CITY OF SUPERIOR  
C. Reiss Dock  
RFQ #23-17-PL

ADDENDUM #3

DATE: April 20, 2023

OFFICE BUILDING SINGLE LINE DIAGRAM  
NOT TO SCALE

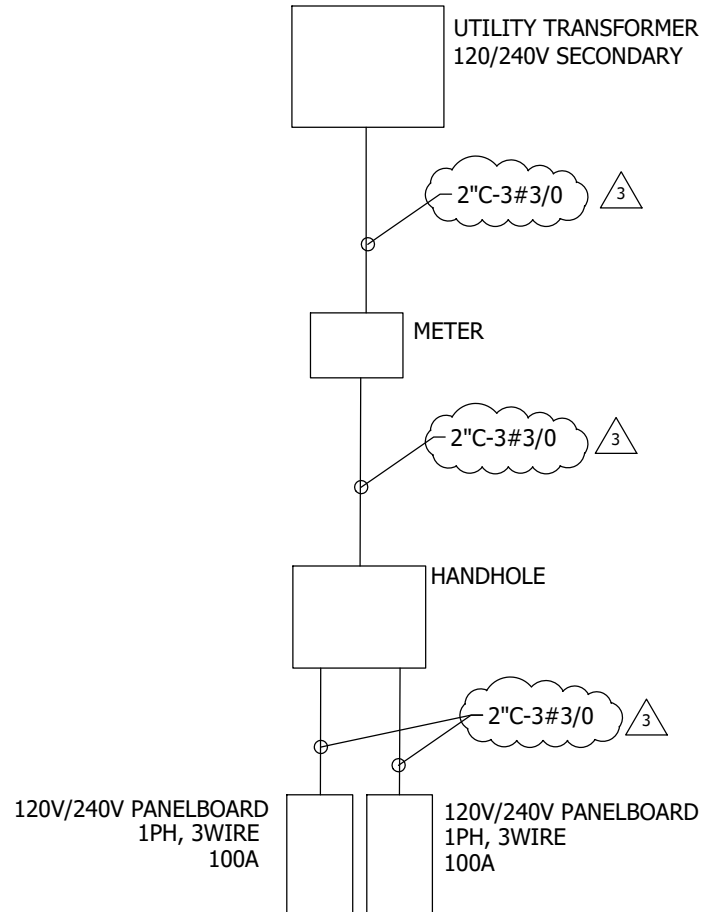
Sheet E-601. (Single-Line and Panel Schedule)

- Single line is calling out for 1phase panelboards but the service wire is for 2" conduit with 4-3/0.... Please clarify the office service requirements.

A: Single phase is correct for the office building. Electrical conduit and wire revised to 3-3/0. See revised Plan Sheet E-601. Panelboard schedules for the office are not currently available but will be provided by Owner prior to construction.

1. Single phase is correct for the office building. Electrical conduit and wire revised to 3-3/0.
